FEBRUARY 2021 | P19-1601

DESIGNERS REPONSE TO STAGE 1 ROAD SAFETY AUDITS

THE POPLARS, LAND SOUTH OF CLIFTON ROAD, DEDDINGTON

ON BEHALF OF BLUE CEDAR HOMES LIMITED

TITLE:	PROJECT No:	DRAWING No:	DRAWING No:	
PROPOSED SITE ACCESS AND POTENTIAL OFF-SITE MITIGATION WORKS	P19-1601	FIGURE	2

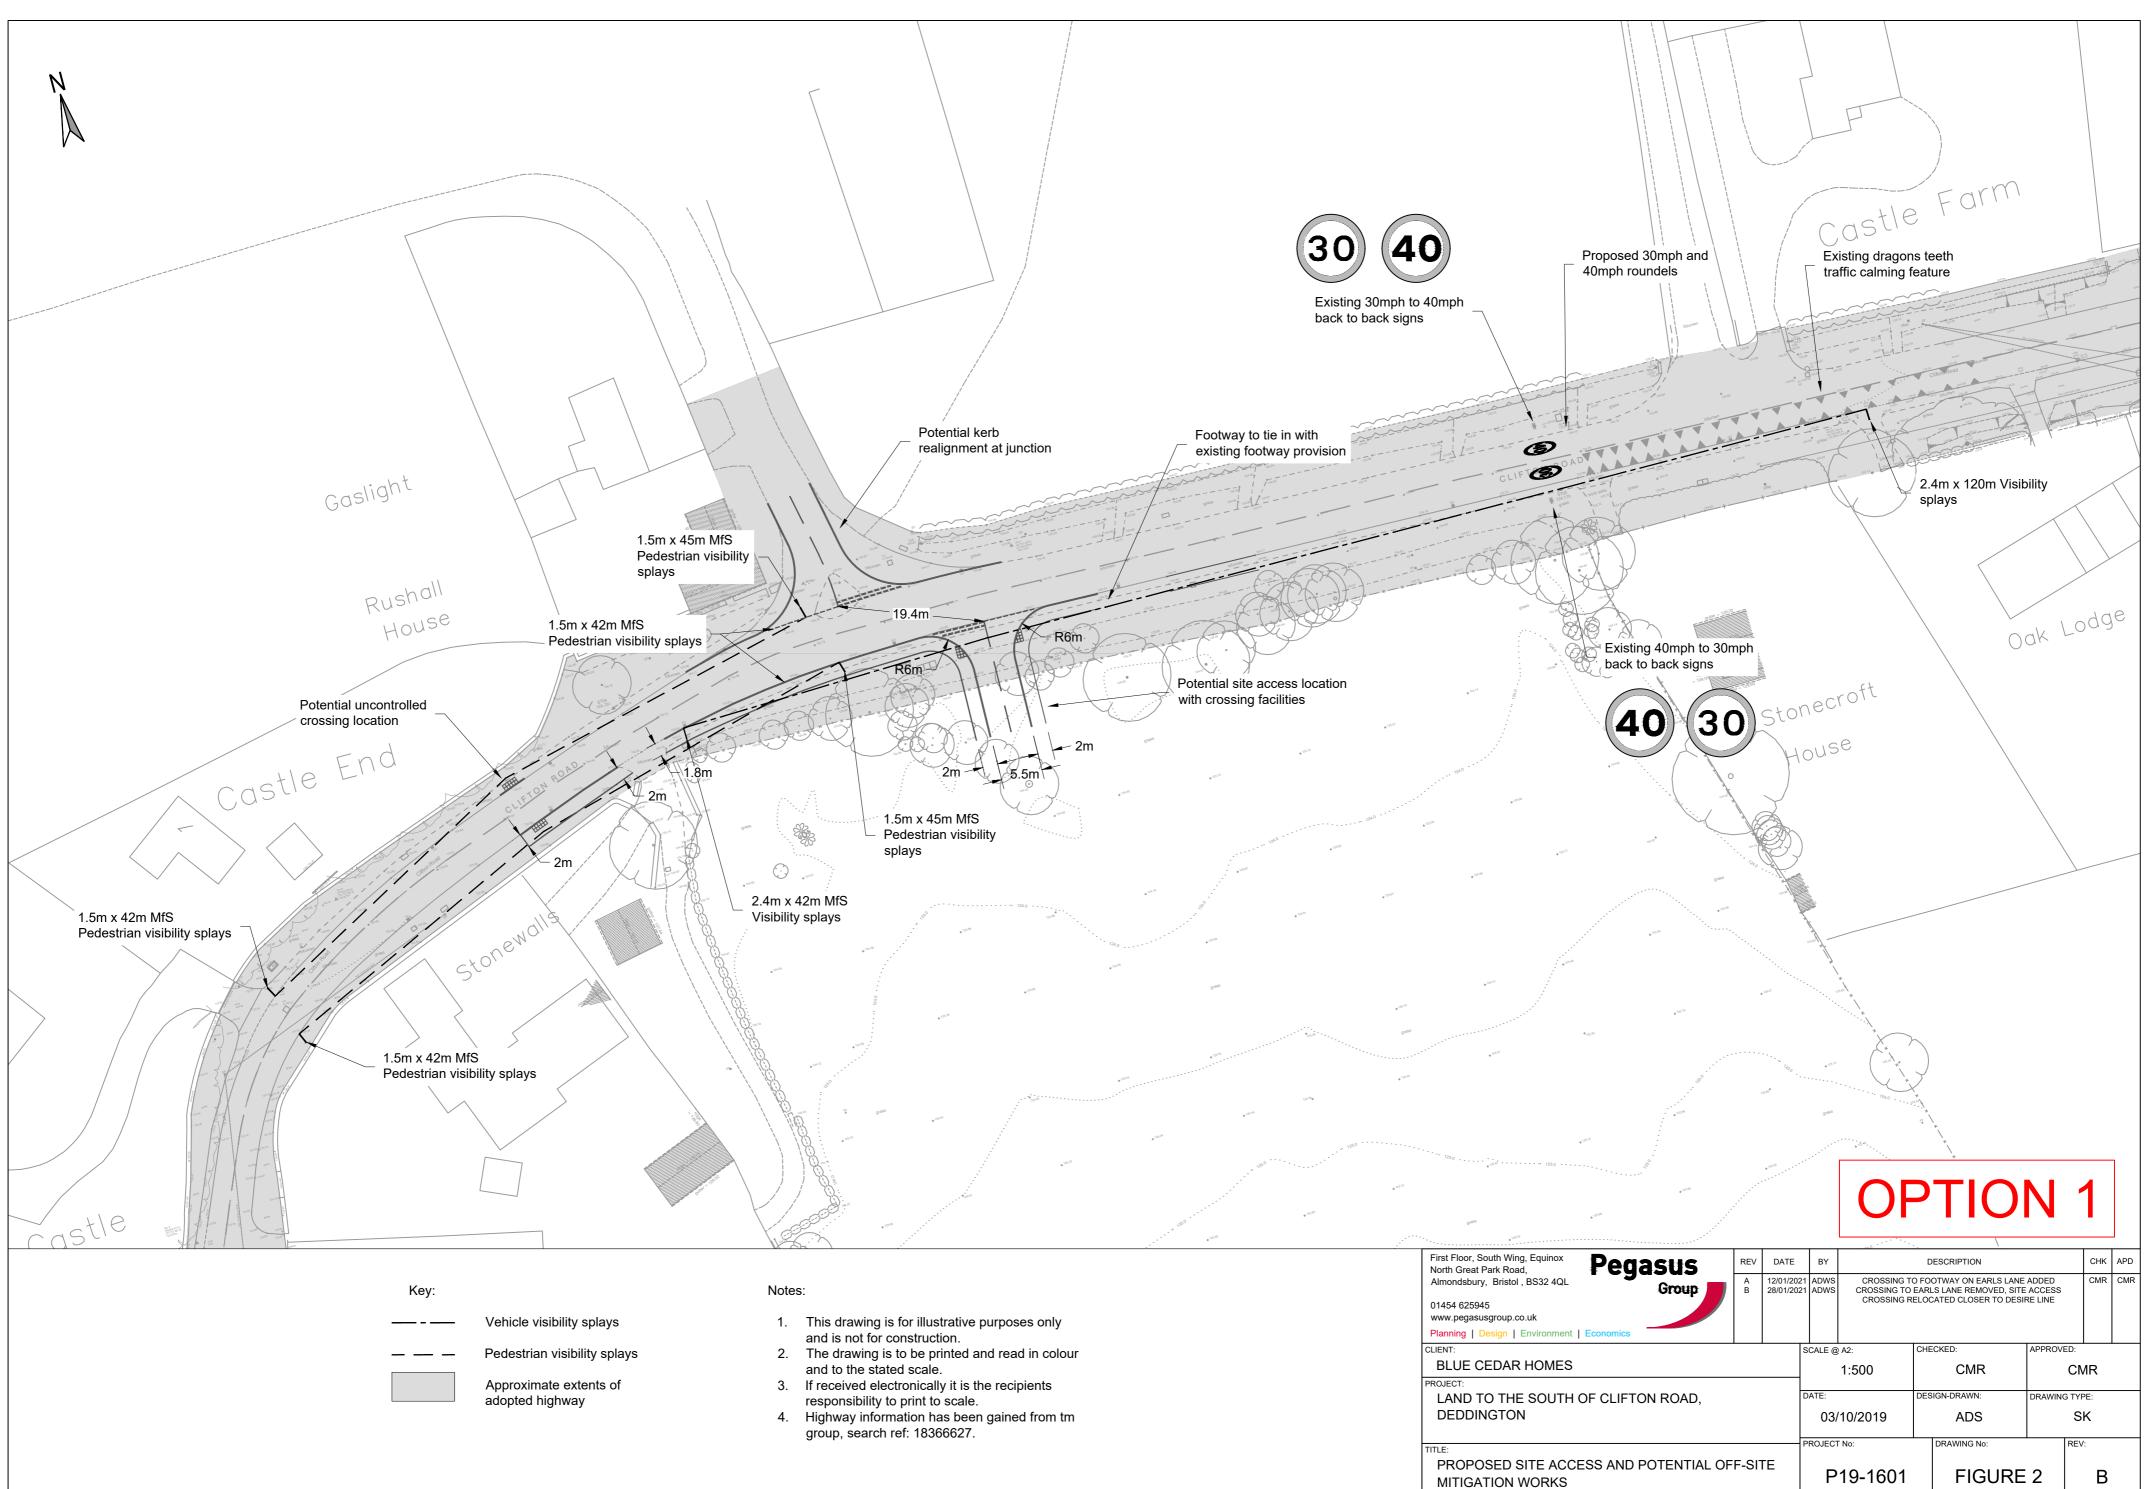
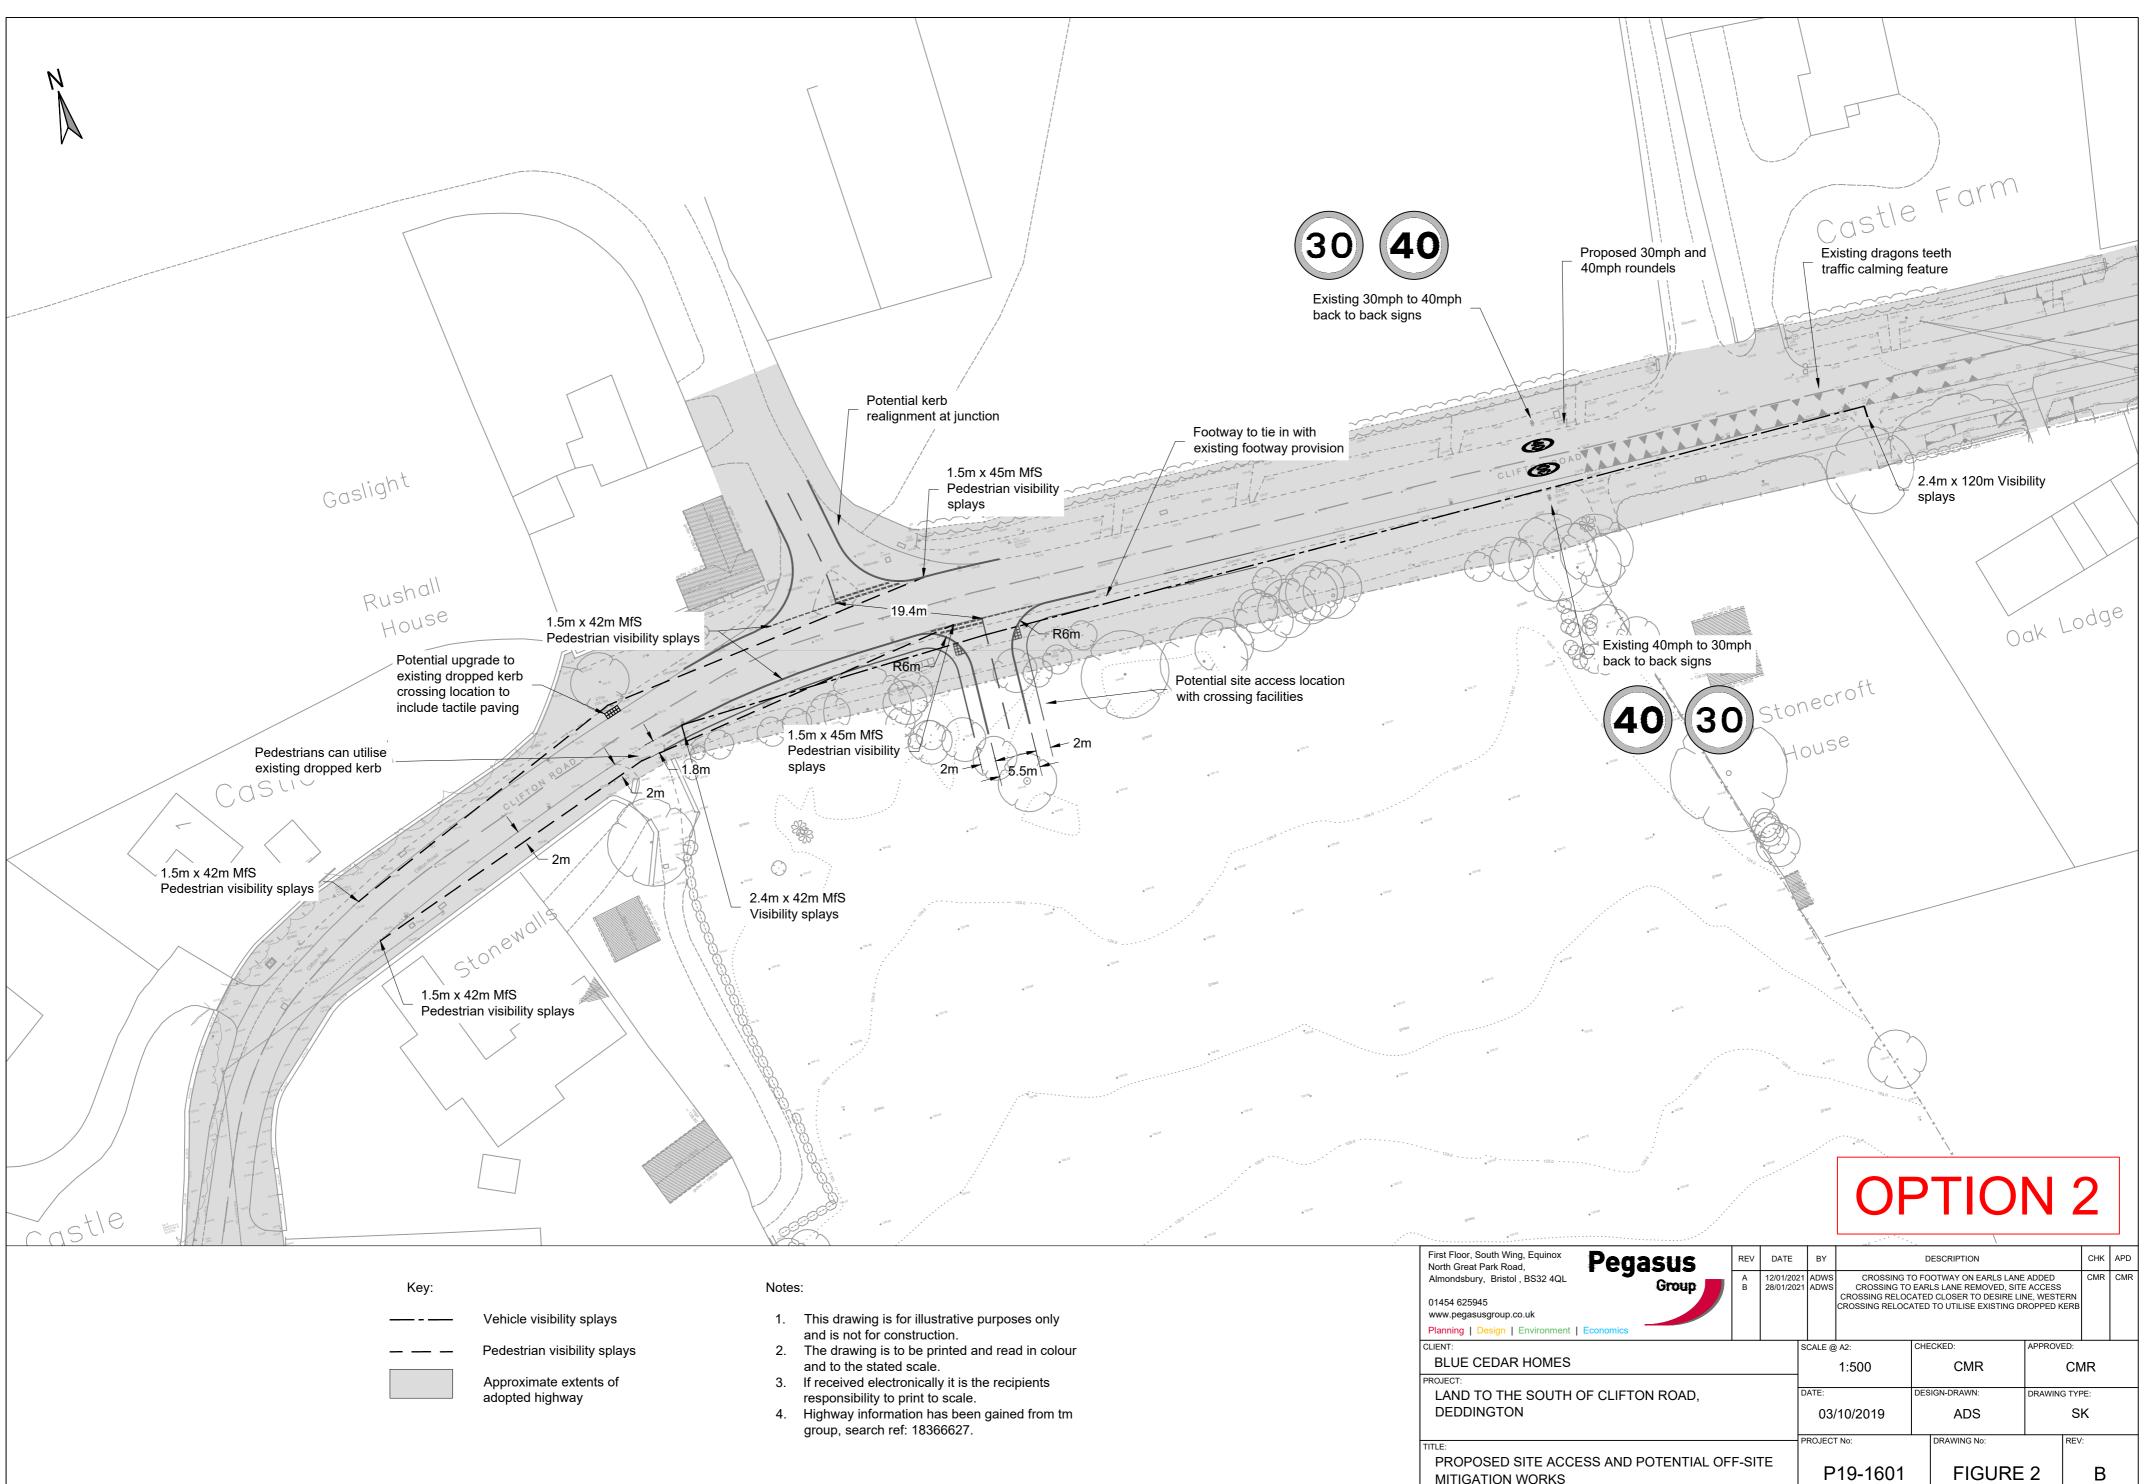
At the proposed new access junction, visibility to the left for drivers of vehicles emerging from the development could be restricted by vegetation in the verge. Restricted visibility could lead to a vehicle pulling out into the path of an oncoming eastbound vehicle.

Adequate visibility splays should be kept free of obstruction, including vegetation and, to ensure that visibility splays remain free of obstruction in the future, the Highway Boundary should be located behind visibility splays.

The proposed uncontrolled crossing is located quite close to a bend in the road, and intervisibility between vehicle drivers and pedestrians on the south side of the crossing could be restricted by a high wall. For pedestrians crossing from the south side, visibility to their right could also be restricted by a boundary wall. These potential visibility restrictions could lead to pedestrians stepping out into the path of oncoming vehicles on Clifton Road.

The proposed new crossing should be located further to the east, immediately to the west of the remodelled junction with Earls Lane.

At the proposed new access junction, visibility to the left for drivers of vehicles emerging from the development could be restricted by vegetation in the verge. Restricted visibility could lead to a vehicle pulling out into the path of an oncoming eastbound vehicle.

Adequate visibility splays should be kept free of obstruction, including vegetation and, to ensure that visibility splays remain free of obstruction in the future, the Highway Boundary should be located behind visibility splays.

The proposed uncontrolled crossing is located on a private driveway access on the south side of Clifton Road. Locating a pedestrian crossing on a private drive could result in conflict between crossing pedestrians and vehicles using the driveway, and lead to collisions between pedestrians and vehicles. This could be exacerbated by pedestrians being required to look for vehicles approaching from three different directions.

The proposed new crossing should be located further to the east away from the driveway, immediately to the west of the remodelled junction with Earls Lane.

Noted. Junction visibility splays are in excess of what is typically sought for the locally measured speeds (dimensions as shown on the drawings) and the fact that they are in publicly maintainable highway land means that they will be able to remain free of obstruction.

Noted. The design has been updated to incorporate this recommendation. P19-1601_001_SK Figure 2 Rev C shows the relocated crossing position with suitable pedestrian visibility splays in excess of what is required for the locally measured speeds (dimensions as shown on the drawing) and is included at **Appendix D**.

Noted. Junction visibility splays are in excess of what is typically sought for the locally measured speeds (dimensions as shown on the drawings) and the fact that they are in publicly maintainable highway land means that they will be able to remain free of obstruction.

Noted. The design has been updated to incorporate this recommendation. P19-1601_001_SK Figure 2 Rev C shows the relocated crossing position with suitable pedestrian visibility splays in excess of what is required for the locally measured speeds (dimensions as shown on the drawing) and is included at **Appendix D**.

Drawing No. P19-1601 Figure 2 Rev B - Option 1

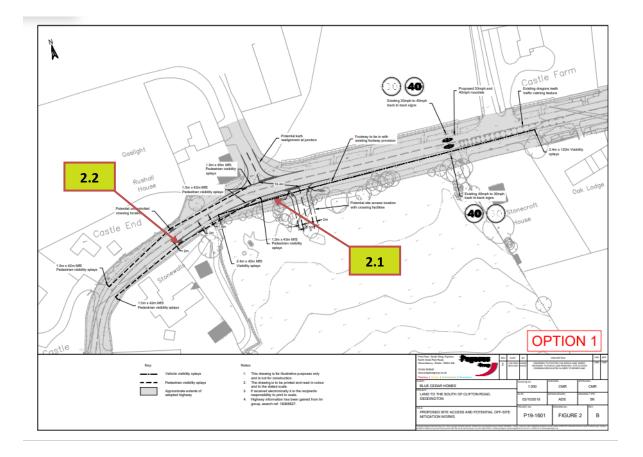
At the proposed new access junction, visibility to the left for drivers of vehicles emerging from the development could be restricted by vegetation in the verge. Restricted visibility could lead to a vehicle pulling out into the path of an oncoming eastbound vehicle.

Adequate visibility splays should be kept free of obstruction, including vegetation and, to ensure that visibility splays remain free of obstruction in the future, the Highway Boundary should be located behind visibility splays.

The proposed uncontrolled crossing is located quite close to a bend in the road, and intervisibility between vehicle drivers and pedestrians on the south side of the crossing could be restricted by a high wall. For pedestrians crossing from the south side, visibility to their right could also be restricted by a boundary wall. These potential visibility restrictions could lead to pedestrians stepping out into the path of oncoming vehicles on Clifton Road.

The proposed new crossing should be located further to the east, immediately to the west of the remodelled junction with Earls Lane.

Drawing No. P19-1601 Figure 2 Rev B - Option 2

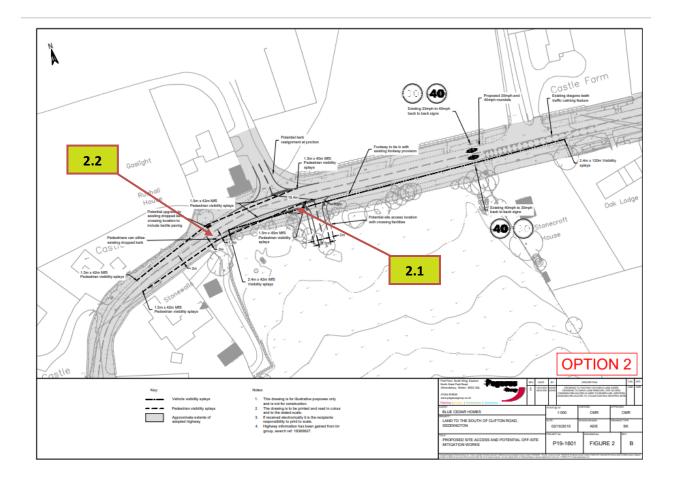
At the proposed new access junction, visibility to the left for drivers of vehicles emerging from the development could be restricted by vegetation in the verge. Restricted visibility could lead to a vehicle pulling out into the path of an oncoming eastbound vehicle.

Adequate visibility splays should be kept free of obstruction, including vegetation and, to ensure that visibility splays remain free of obstruction in the future, the Highway Boundary should be located behind visibility splays.

The proposed uncontrolled crossing is located on a private driveway access on the south side of Clifton Road. Locating a pedestrian crossing on a private drive could result in conflict between crossing pedestrians and vehicles using the driveway, and lead to collisions between pedestrians and vehicles. This could be exacerbated by pedestrians being required to look for vehicles approaching from three different directions.

The proposed new crossing should be located further to the east away from the driveway, immediately to the west of the remodelled junction with Earls Lane.
